# Local Planning Panel

598-610 Crown Street, Surry Hills

D/2023/902

# Proposal

ground floor demolition plan

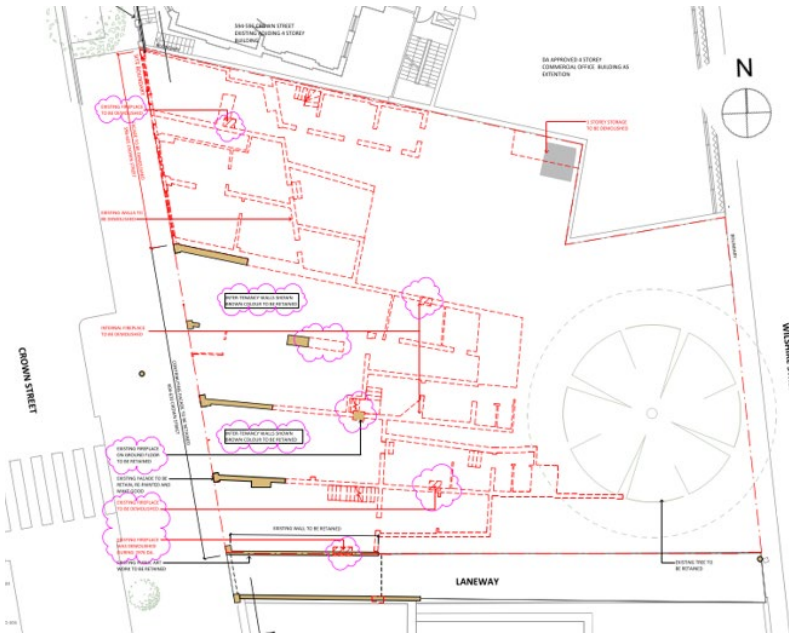
- site comprises a neutral building (598-602) and a row of four contributory buildings (604-610)
- complete demolition of neutral building and significant demolition of contributory buildings proposed
- Pre-DA and DAP advice supportive of demolition of neutral building, subject to retaining as much as possible of contributory buildings
- facade, portions of internal walls, and balconies of contributory buildings retained

Detailed section through infill building  
(recommended ceiling profile shown in green)

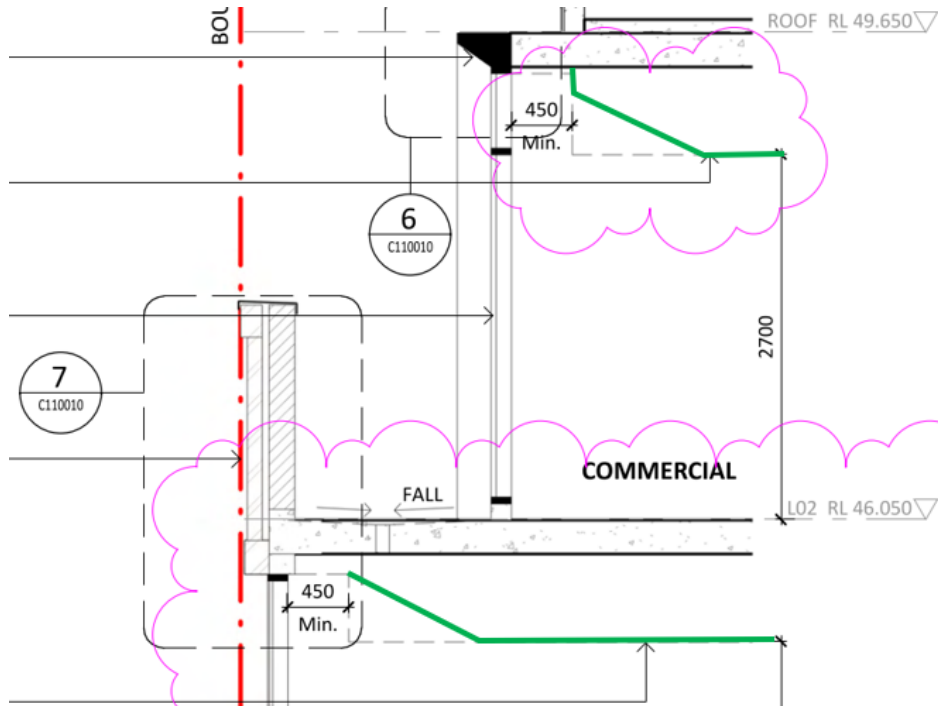
- splayed corner of the infill building (598-602) maintains visual prominence of the adjoining heritage building (594-596)
- simplified design of infill building is consistent with DAP recommendations
- recommended that the interface of the ceilings of the infill building be angled away from Crown Street
- recommended that the awnings to the contributory buildings be retained in full
